**LEVY NUCLEAR PLANT, UNITS 1 AND 2
DOCKET NOS. 52-029 AND 52-030
RESPONSE TO NRC RAI LETTER 114 – SRP CHAPTER 8.0, ELECTRICAL POWER**

**Levy Nuclear Plant Units 1 and 2 (LNP)
Response to NRC Request for Additional Information Letter No. 114 Related to SRP
Chapter 8.0, Electrical Power, Dated 8/14/2013**

NRC Letter No.: LNP-RAI-LTR-114

DEF RAI ID #: L-1062

Figure 1: Main AC Power Station Simplified One-Line Diagram

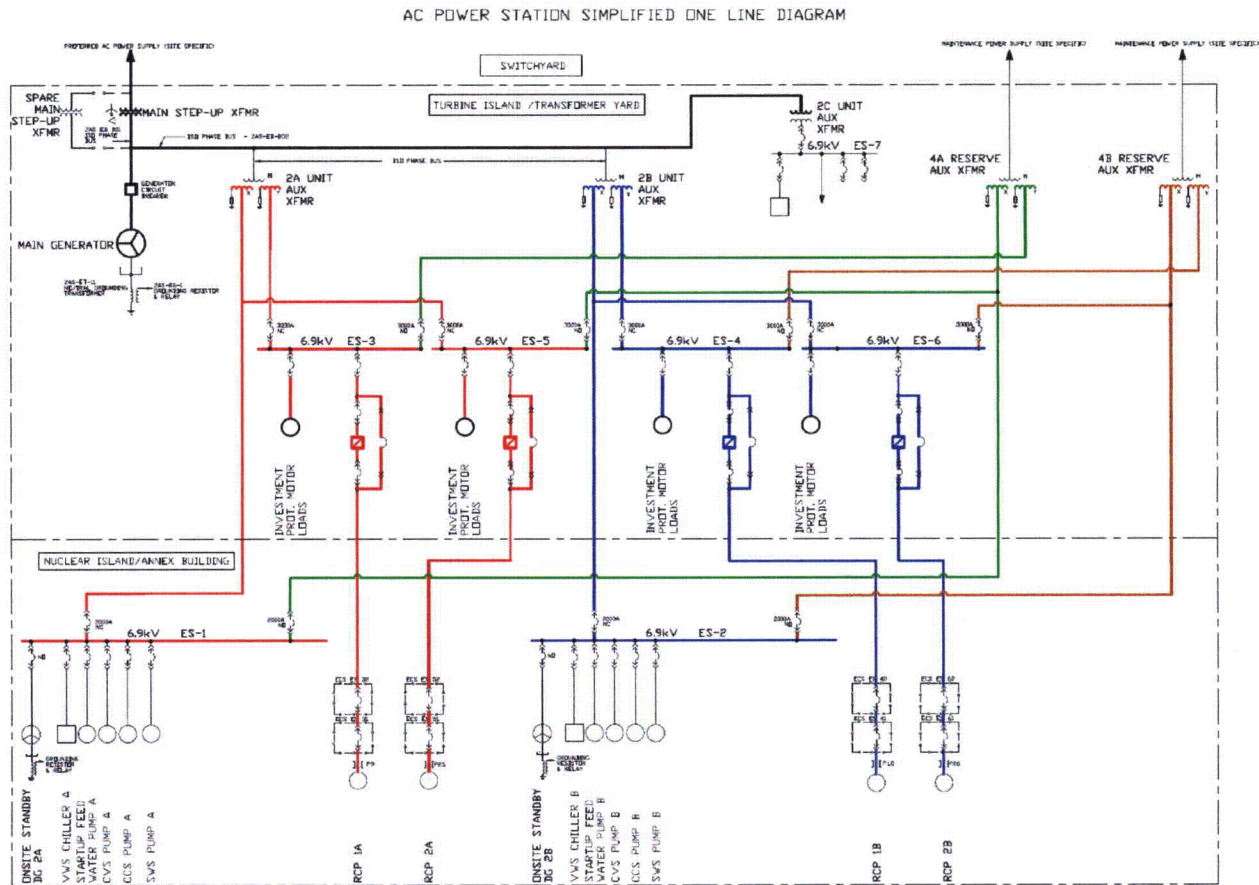
Identify which offsite circuit is credited to meet the GDC 17 requirements, considering the partial exemption for AP1000 plants.

The credited GDC 17 offsite power supply for the AP1000 plant is the Preferred AC Power Supply shown in Figure 1. The Preferred AC Power Supply is backfed through the three single phase main step-up transformers (MSUs), labeled "MAIN STEP-UP XFMR" as shown on Figure 1. The Preferred AC Power Supply is connected to the main generator bus and through the unit auxiliary transformers (UATs) 2A and 2B to the plant electrical distribution system.

Because of its passive safety features, the AP1000 passive plant does not require AC power to place the plant in a safe, stable shutdown condition. The AP1000 design was granted a partial exemption from GDC 17, specifically exempting the AP1000 plant from the requirement for a second GDC 17 credited offsite power source. Therefore, a second credited source of AC power from the power grid is not required. The Onsite Standby Power System (ZOS), powered by onsite standby diesel generators 2A and 2B, provides an alternate source of AC power to the plant electrical distribution system through medium voltage buses ES-1 and ES-2 for defense-in-depth shutdown loads.

Because of the partial GDC 17 exemption, the Maintenance Power Supply, fed through reserve auxiliary transformers (RATs) 4A and 4B, is not considered a credited GDC 17 power source. However, the medium voltage buses ES-1 and ES-2 can be manually aligned to receive power through the RATs. The medium voltage buses will automatically transfer from the UATs to the RATs in the event the credited Preferred AC Power Supply becomes unavailable due to an electrical fault at either the MSU, the isophase bus, the UATs or the 6.9 kV nonsegregated bus duct.
